MONTANA FISH, WILDLIFE & PARKS

ADDENDUM NO. 1

PROJECT: Big Snowy Mountains WMA 2024 Fencing

FWP PROJECT #: 75862

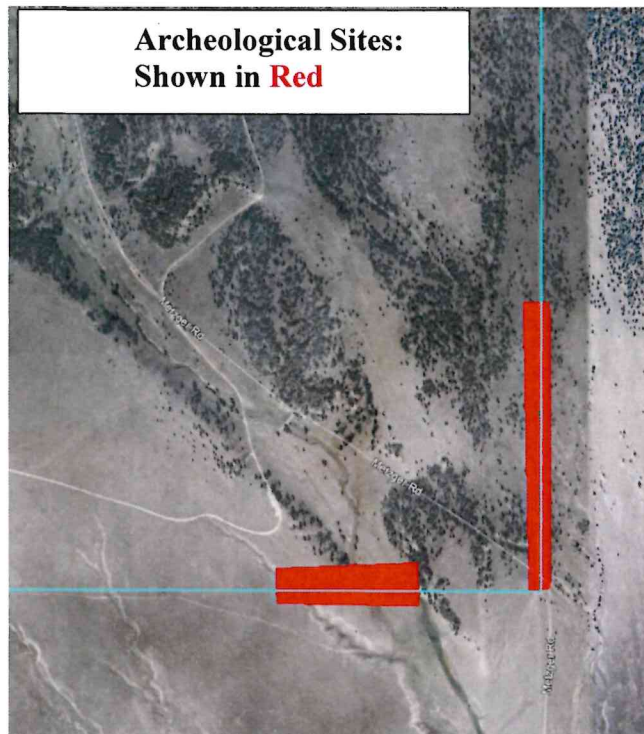
Q. Fencing Line Construction Monitoring The construction of this project passes through archaeological sites that are sensitive and second party monitoring is required in these areas. While working in these areas:

- No heavy equipment can be used and equipment shall be limited to use of all terrain vehicles (ATV's).
- A FWP State Representative must be present at all times while working in these areas to insure conformance.
- Existing fence in that area will be removed carefully and, if possible, by hand to minimize ground disturbance.
- Placement of new posts must be approved by on-site representative prior to placement.
- The areas where monitoring needs to occur is shown in the image below.

In the image, the area shown in red occurs between points A, N, and M as shown on sheet 3 of the Plans. The rest of the fence install does not need to be monitored.
